**ALERT SERVICE BULLETIN**  
**Bell Helicopter** **TEXTRON**

NO. 206-07-113

**SUBJECT:** CARGO HOOK STRESS CORROSION CRACKS

Document No. 159-017-00 Rev 0

**Figure 1. Crack location**

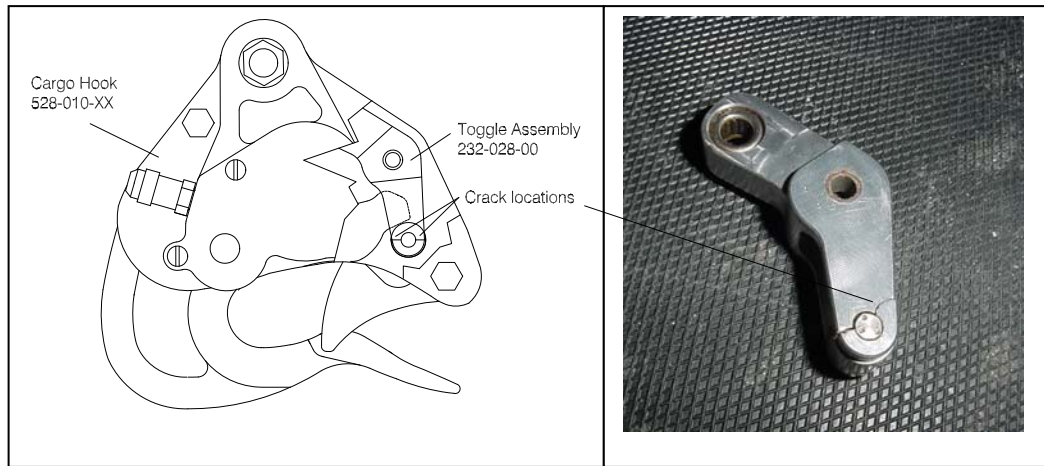
**Description:** Onboard Systems has had two reported instances of failure of the Toggle Assembly, 232-028-00. The Toggle is an internal component of Cargo Hook 528-010-XX and is a primary element of the Cargo Hook locking mechanism. Figure 1 shows the location of the failure.

**Cause:** Investigation of the failures has suggested that they were caused by Stress Corrosion Cracking (SCC). Specific mechanical, metallurgical, and corrosive conditions must be present in order for SCC to occur.

In the case of the Toggle Assembly, these conditions were satisfied by—

1. Residual stresses imposed by the press fit of the Load Beam Roller Pin
2. Corrosive salt water environment

1. Visual check to see if cracks are visible in the Toggle. This must be accomplished before further Cargo Hook use and daily prior to external load operations until item 2 is accomplished. If cracks are found, the Cargo Hook must be removed from service and part 2 accomplished before additional use.
2. Replace the original Toggle with a redesigned Toggle, 232-028-01, at the next scheduled overhaul, or within one year from the approval date of this bulletin, whichever comes first.

**Figure 2. Crack Locations in Toggle 232-028-00**

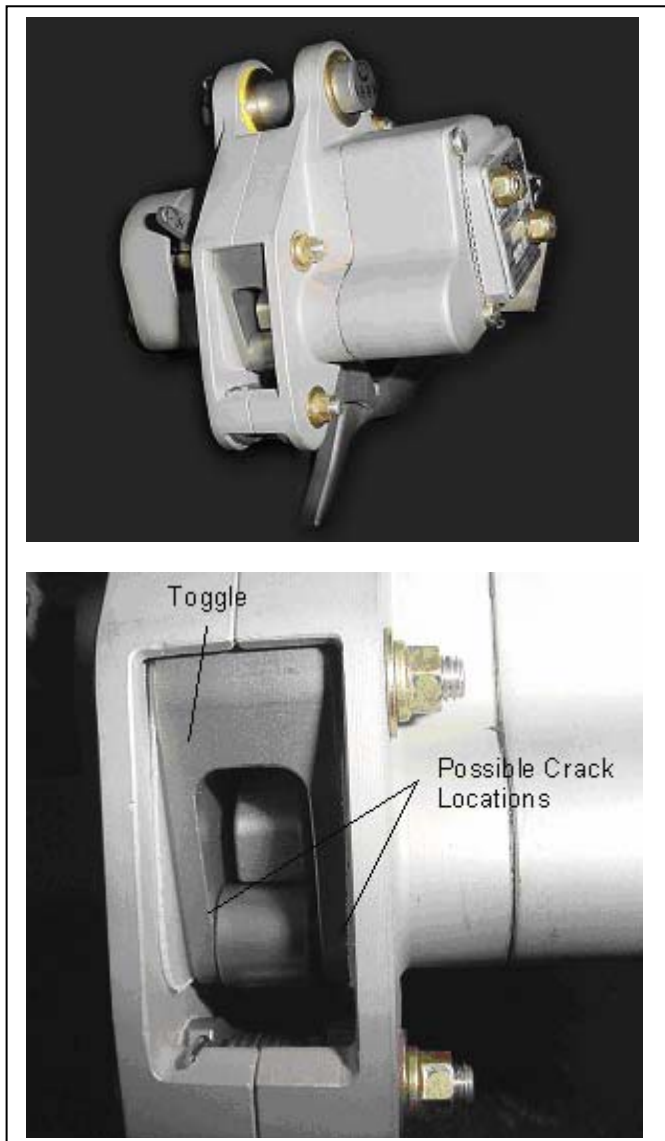
1. Visually check the Toggle for cracking or separation, as viewed in figure 2 in the assembled Cargo Hook.
2. Operate the Cargo Hook per the preflight instructions in the RFMS. If the Cargo Hook does not function properly, it must be removed from service and the part 2 instructions must be accomplished prior to use.

**Figure 4. Install New Thrust Plates.**

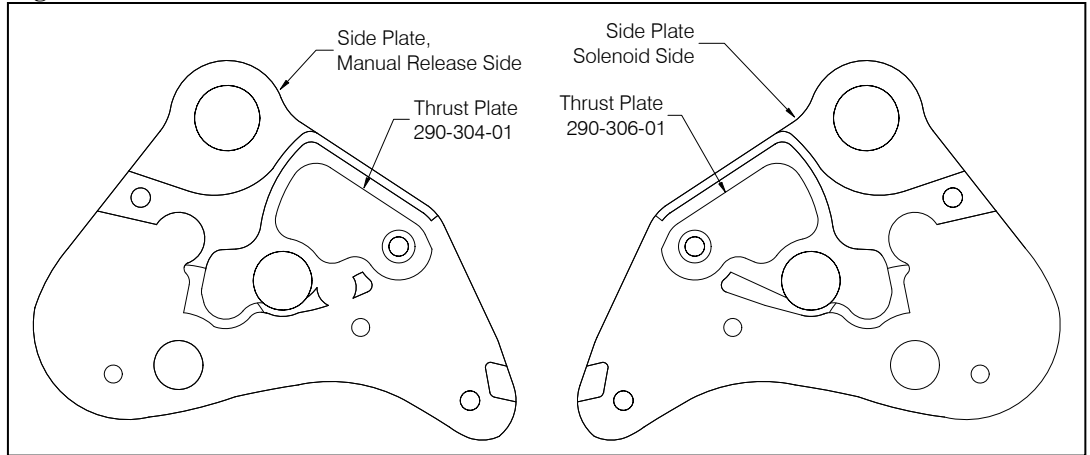
3. Remove Thrust Plates 290-306-00 from the inside of the cargo hook side plate on the solenoid side and 290-304-00 from the inside of the opposite side plate and replace with Thrust Plates 290-306-01 and 290-304-01 respectively as shown in Fig. 4\*\*.

*\*\*The Thrust Plates must be replaced or the new Toggle will not function properly.*
